## CAP Meeting Agenda

**ITEM 4.1****DEVELOPMENT APPLICATION – 24020071 – 10 CARLTON STREET, HIGHGATE**

<b>DEVELOPMENT NO.:</b>	24020071
<b>APPLICANT:</b>	Lee Li
<b>ADDRESS:</b>	10 CARLTON ST HIGHGATE SA 5063
<b>NATURE OF DEVELOPMENT:</b>	Demolition of the existing dwelling and construction of a double storey detached dwelling with cellar, swimming pool, outbuilding and fencing.
<b>ZONING INFORMATION:</b>	<p><b>Zones:</b></p> <ul style="list-style-type: none"> <li>• Established Neighbourhood</li> </ul> <p><b>Overlays:</b></p> <ul style="list-style-type: none"> <li>• Airport Building Heights (Regulated)</li> <li>• Affordable Housing</li> <li>• Historic Area</li> <li>• Heritage Adjacency</li> <li>• Prescribed Wells Area</li> <li>• Regulated and Significant Tree</li> <li>• Stormwater Management</li> <li>• Traffic Generating Development</li> <li>• Urban Tree Canopy</li> </ul> <p><b>Technical Numeric Variations (TNVs):</b></p> <ul style="list-style-type: none"> <li>• Maximum Building Height (Metres) (Maximum building height is 6m)</li> <li>• Minimum Frontage (Minimum frontage for a detached dwelling is 12.5m)</li> <li>• Minimum Site Area (Minimum site area for a detached dwelling is 40

**Figure 6 & 7 – Side Boundary Setback of Proposed Development**

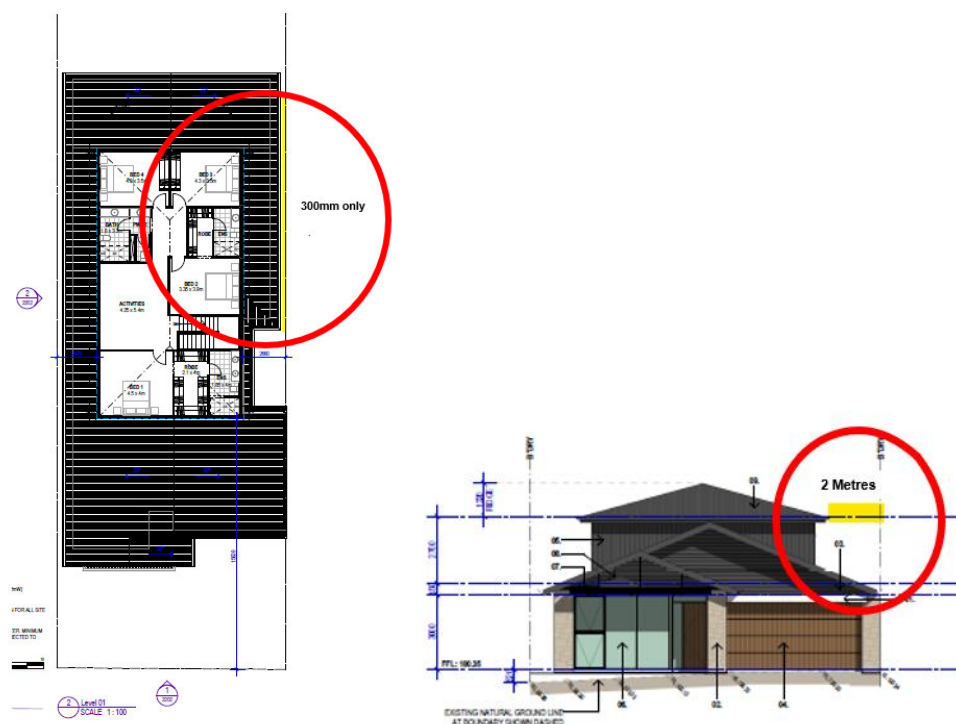
The proposed development is proposing a side boundary setback of approximately 30 centimetres from the eave of the roof of the first building level and 1 metre to the boundary wall.

For the second building level it is proposing a separation of 2 metres to the eave of the second building level and 2.65 to the second building level wall. As can be seen in the Figures 6&7 below.

Therefore, the Planning and Design Code calls for the side boundary setback to include both the wall and the roof eaves to be setback, not just the walls as suggested by the applicant.

Representor 3 has asserted that the side setbacks for both the ground and upper levels are not compliant. In response to this assertion, it should be noted that Representor 3's measurements were taken from the gutter line, not the walls of the proposed dwelling, and that DPF 8.1 of the EN Zone refers to 'building walls', not 'gutters'. For clarity, PO 8.1 of the EN Zone and the corresponding DPF, namely DPF 8.1, both of which relate to side boundary setbacks, collectively state:

**Figure 1** Ariel view of the site and surrounding properties (two-level dwellings identified in red)

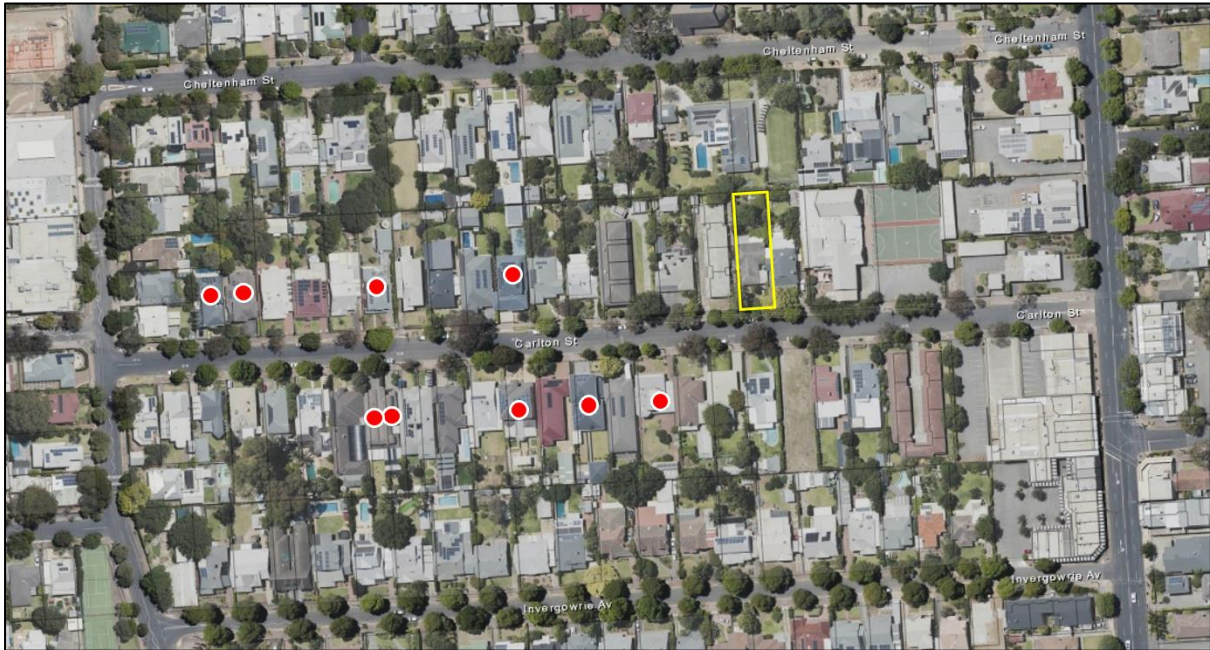
While a handful of newer two storey and single storey dwellings are located towards the western end of Carlton Street, the immediate locality is predominantly single-storey character dwellings as shown in the Figure 2 and 3 below.

Notwithstanding, our inspection of the site and its surroundings revealed that nine dwellings consist of two ‘building levels’ (see Figure 1 on Page 3), with the majority of these dwellings displaying highly prominent upper levels which project straight up from the building line (see Figure 3 on Page 5).

**Figure 2** Figure 3 Extract of drawing A2202 of the application plans

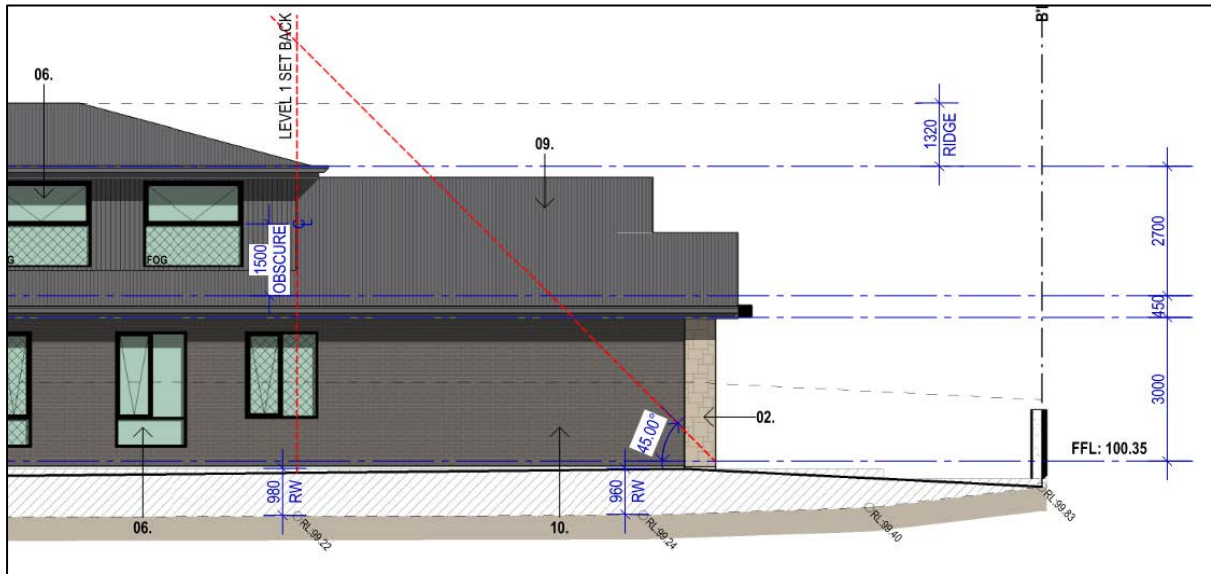
- 12 Metres (approx.) **Noting that the elevation plans do not even show the height of the sub floor level**) 8.5 metres<sup>2</sup> above ground level; and
- 2 building levels

The Proposed Development clearly exceeds the quantitative building height provisions of the Planning and Design Code of 6 metres and 1 building level.

We acknowledge that the proposed dwelling exceeds the maximum height prescribed for buildings in the EN Zone by one ‘building level’ and up to 1.6 metres.

As seen within **Figure 2** on Page 4, the upper level of the proposed dwelling has been designed to comply with Clause (b) of DPF 4.2, in that it is set back behind the building line and does not project beyond the 45-degree angle.
